Our ref: 09123
18 February 2013

Joint Regional Planning Panel (Sydney East)

RE: 2012SYE092 – Leichhardt - D/2012/429 - Demolition, remediation, mixed use development (residential, retail & industrial), parking, new road, sales office /display units, signs & subdivision - 118-120 Terry Street, Rozelle

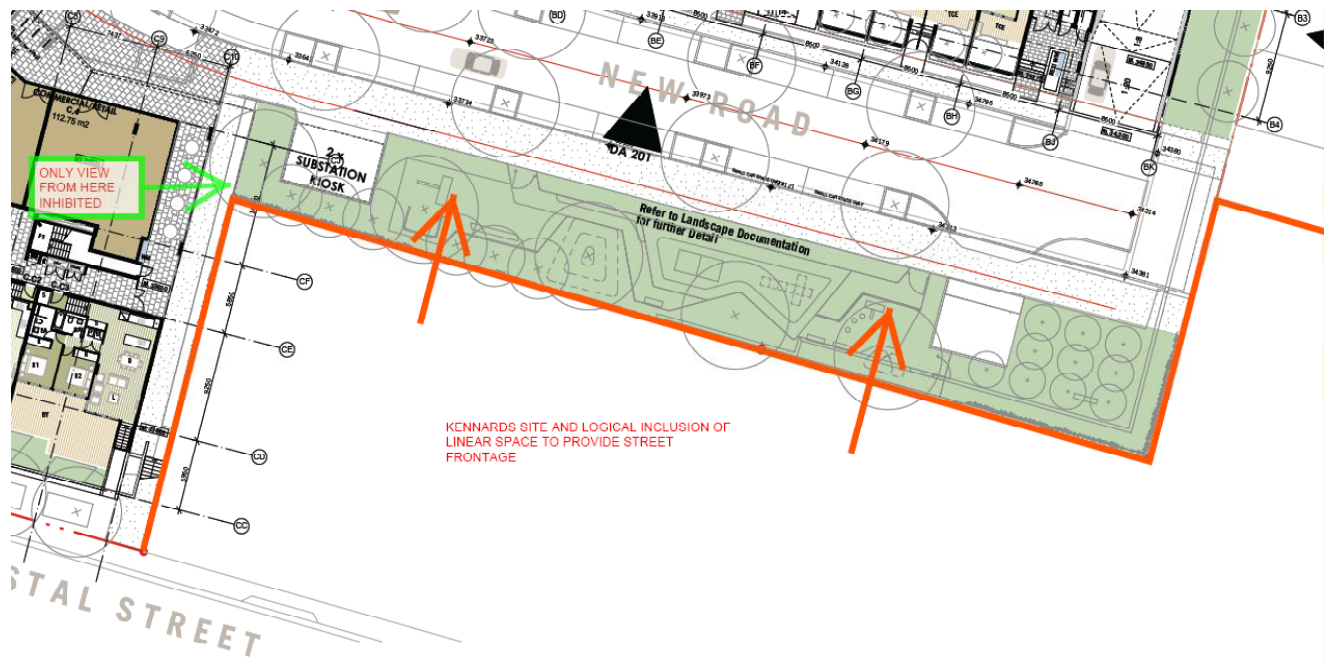
Being a podium area above a carpark, the landscaped areas are provided in the form of planter boxes, the finished level of which sits above the 'trafficable' paths within this area. The relevant levels are shown in the following sketches. As can be seen, the proposed finished level of the trafficable areas is at RL34.6m as required. The planted areas have a higher finished level however these will be densely planted (as required) and will be accessible for maintenance purposes only. The required security fencing will be located on the boundary so the landscaping areas can be suitably maintained.

Accordingly to clarify the intent of the condition, we request that a) be amended to read as follows:

- a) *The finished level of the trafficable areas of the podium adjacent to 126 Terry Street~~courtyard/landscaped area~~ is not to exceed RL 34.6.*

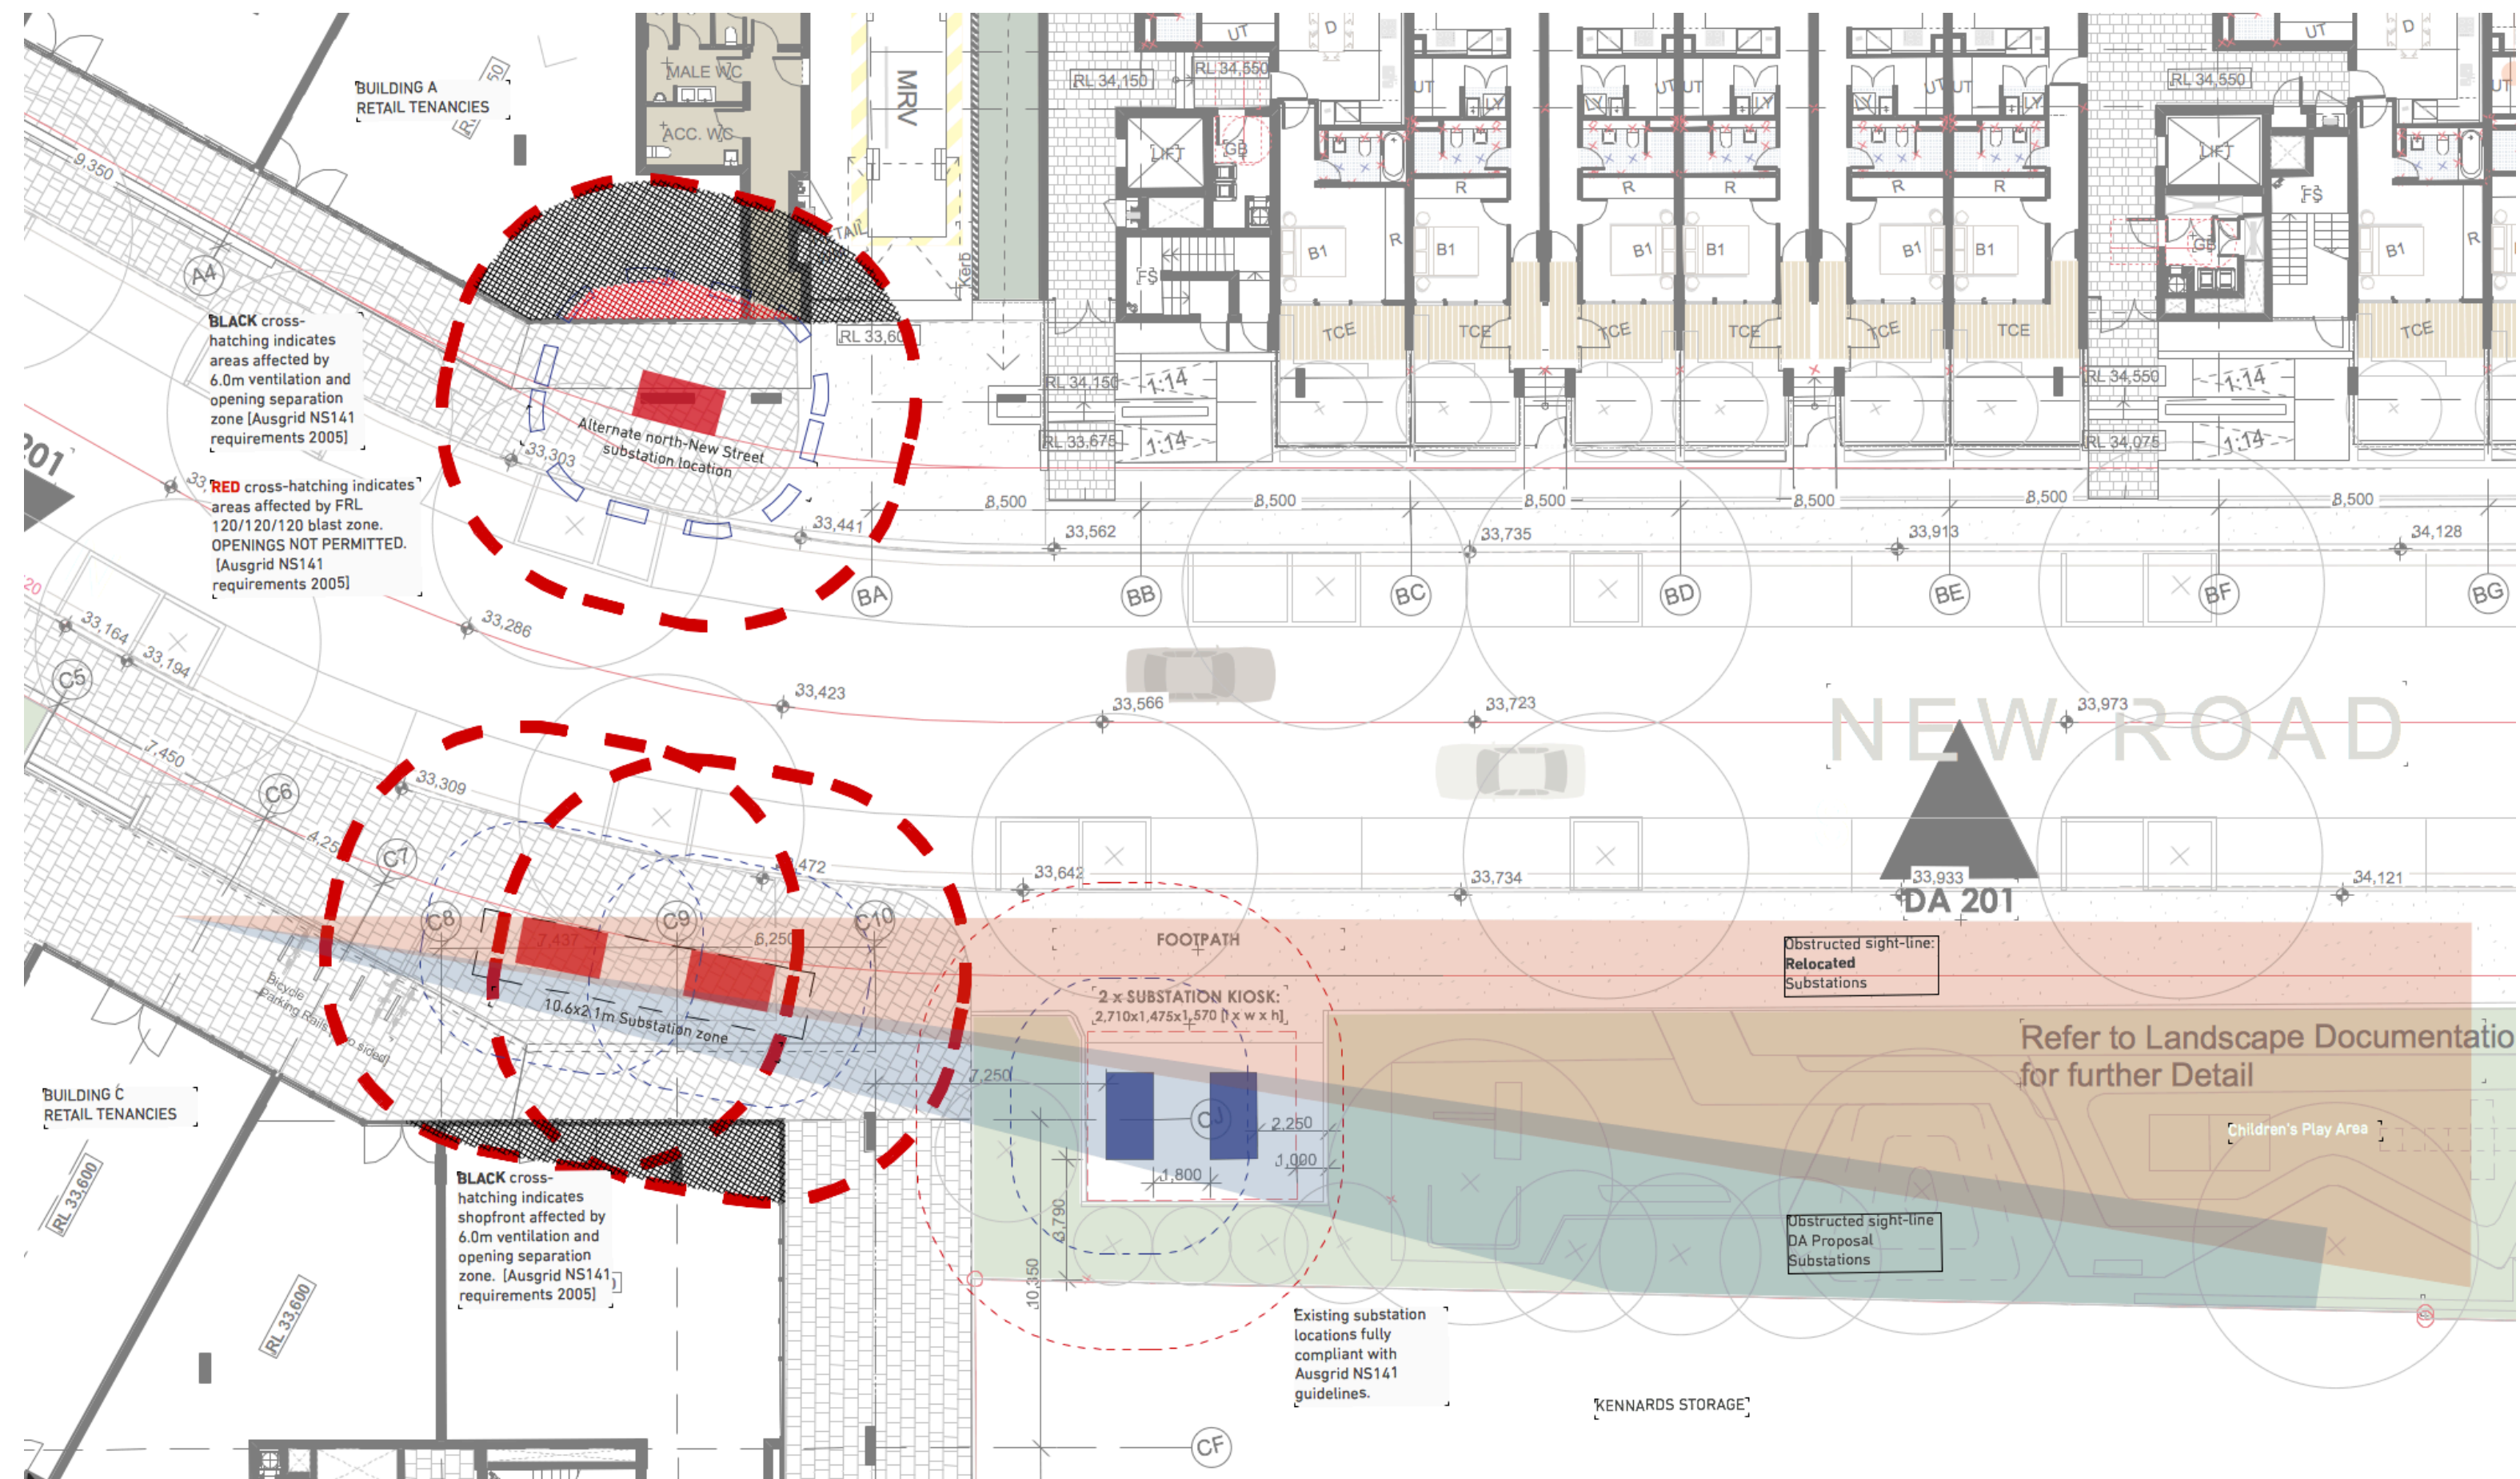
Due to the nature of the space, it has not been designed to be an integral part of the development. Its medium to long term use is likely to be part of the redevelopment of the adjoining large 'Kennards' site as this space would given that site frontage to the New Street and ensure that future buildings do not 'turn their back' on this street. It is effectively 'left over' space that can only logically be used for temporary landscaping/open space until adjoining land is developed (see following diagram).

It is excess to the site specific DCP provisions which require 2000sqm of communal open space. In this regard even without this area the development provides over 4000sqm of communal space. Given this, it would not be unreasonable for the applicant to make this a landscaped area only, without any recreation use.

As noted above, it is not intended that this area is 'integrated' with the adjacent retail area because it is potentially only a 'short term' use and because it is will be privately owned and as such, public liability is a significant issue. In this regard the ability for users of the immediately adjoining retail area to be able to supervise children using the park is not encouraged as it is designed for small children and small children should be supervised at close quarters. The proposed substations and perimeter planting inhibit the view from the closest retail space (C04) and this is seen as a positive in this context, not a negative as portrayed by Council (see above).

Project		TERRY ST ROZELLE	
Title		TERRY ST ROZELLE MARGARET ST TRUCK TURNING PATH - 8.8m	
Status	SKETCH	Drw No.	60223916-SKE-CI-0011
Rev.	01

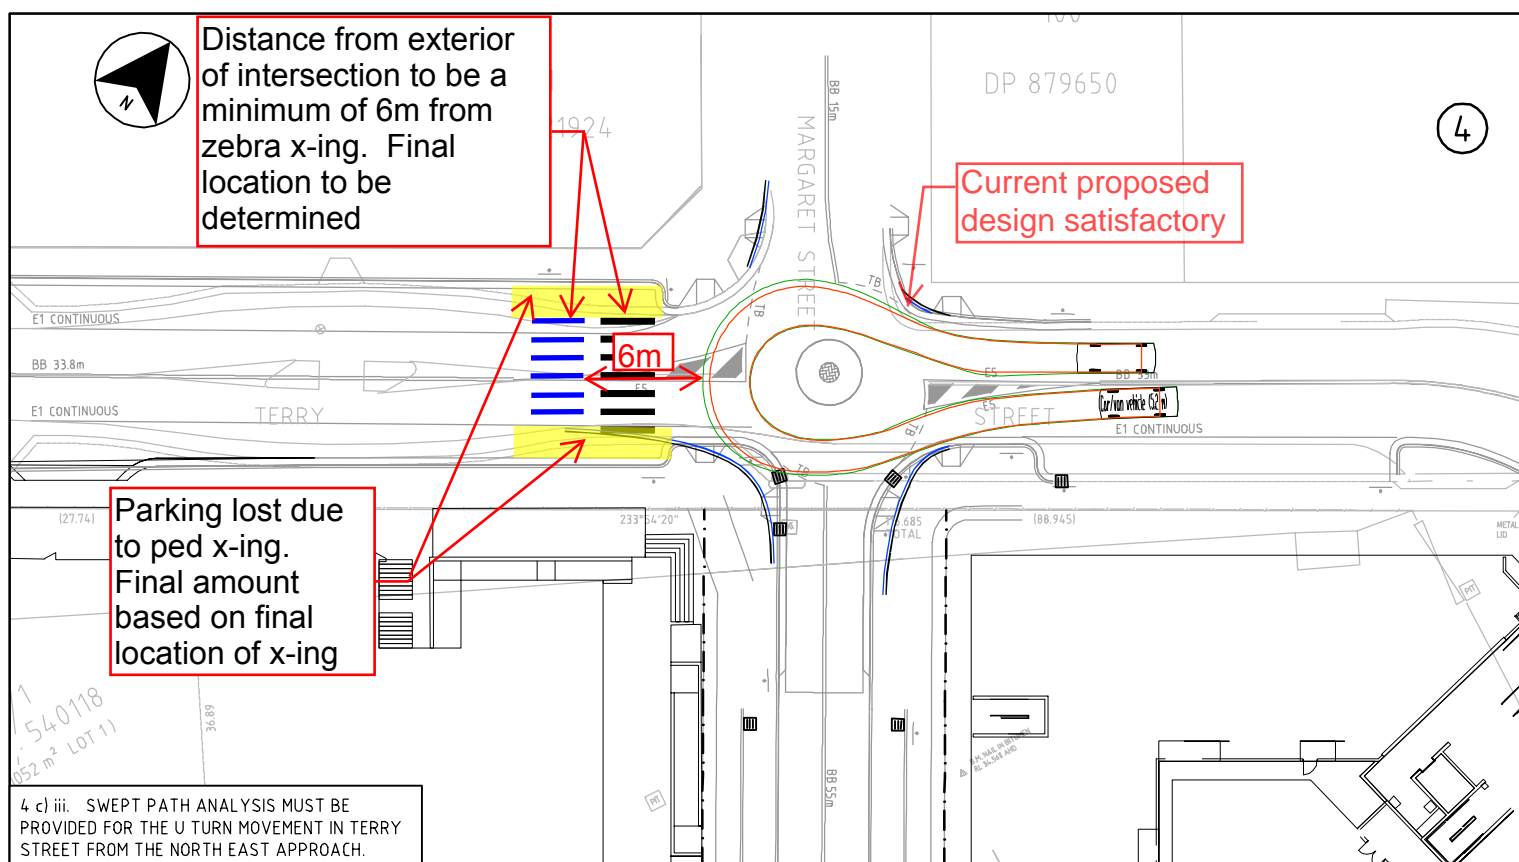
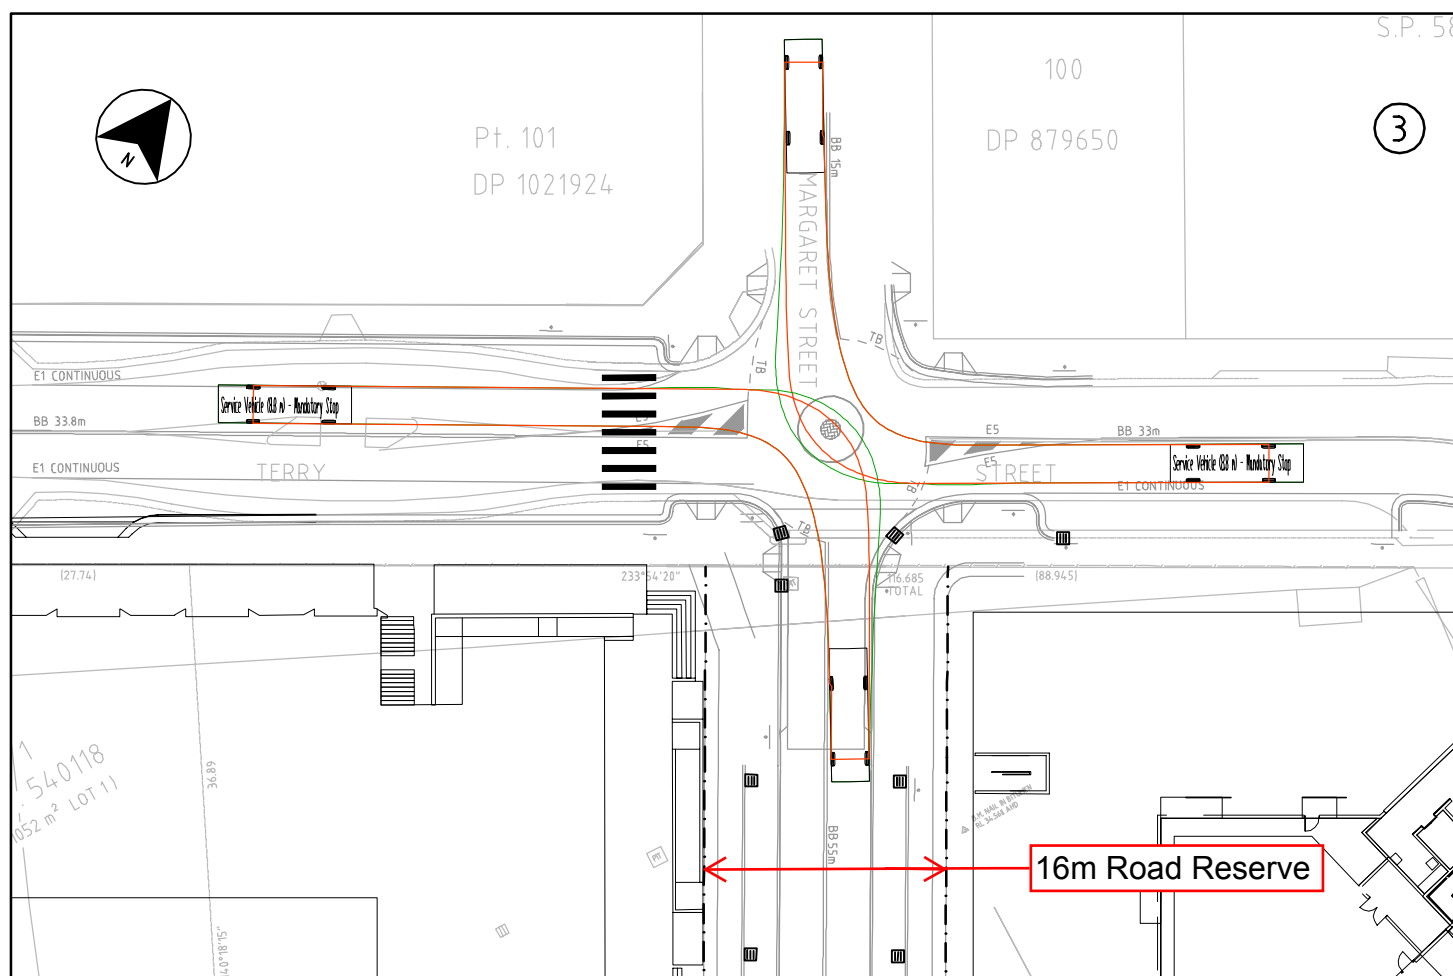
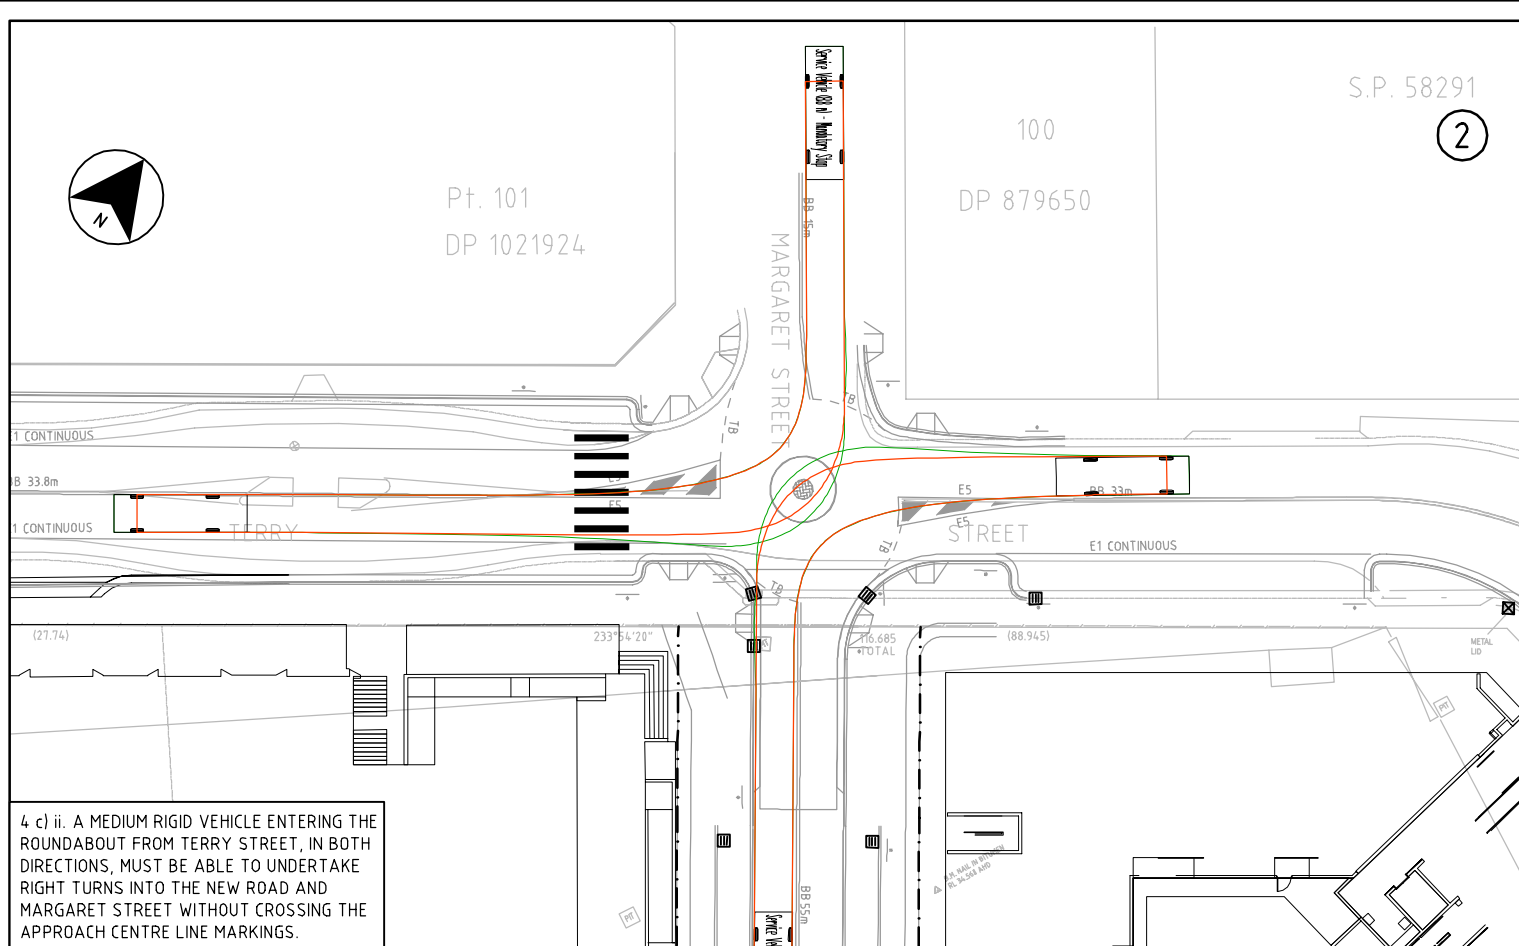
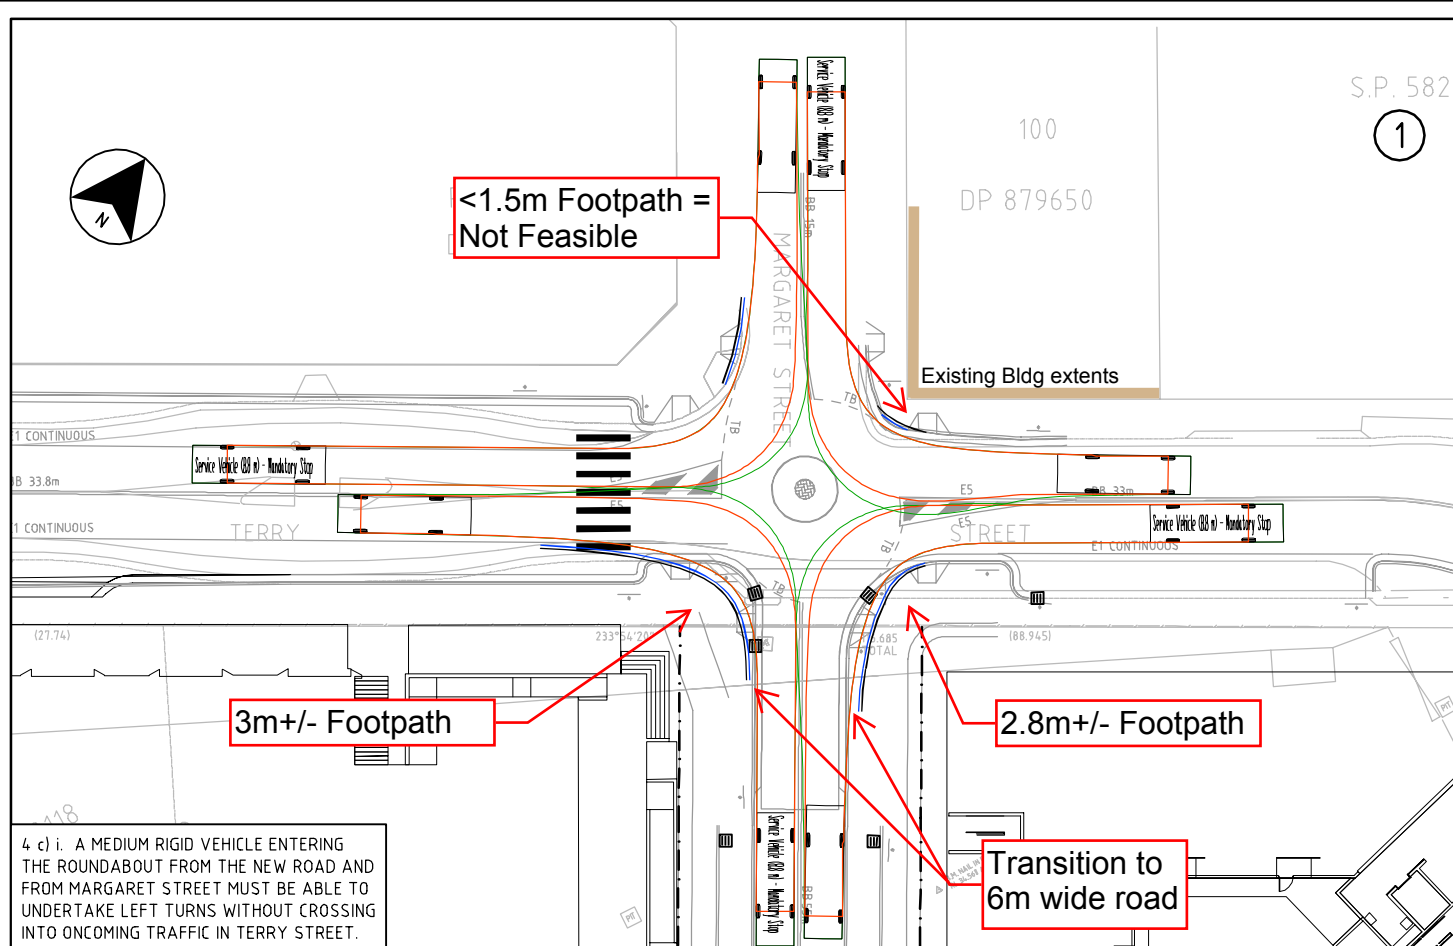
As indicated in the following plans from Aecom, full compliance will result in some unforeseen and/or unacceptable outcomes:

- As indicated in diagram 1, compliance for an MRV turning left into Terry Street from Margaret Street would result in a footpath width on the northern side of the Margaret/Terry Street intersection to be reduced to less than 1.8m. In our view, this is an unacceptable outcome. Further we note that this is an existing situation unrelated to the site, that is not altered or affected by the proposal. Accordingly, the reference to Margaret Street in condition 4c)i. should be deleted.
- As indicated in diagram 1, left hand turns into and out of New Street will reduce footpath widths to as little as 2.8m. It will result in the loss of an existing street tree which is required to be retained by condition 54 and also the loss of parking spaces. Whilst this outcome is not desirable, it would be acceptable to the applicant if Council is satisfied that it achieves compliance with part c)i.

Diagram 4 indicates the requested U turn movement. The amendments indicated above will allow this movement to be accommodated.

NOTE: REVISED KERB LOCATIONS SHOWN INDICATE TURNING PATHS TO ALLOW FOR GENERAL PRACTICE (BLUE) AND APPROXIMATE COMPLIANCE WITH AUSTRoads STANDARDS (BLACK). RAISED PEDESTRIAN CROSSING PROXIMITY TO BE REVIEWED FOR SAFETY COMPLIANCE TO AUSTRoads STANDARDS.
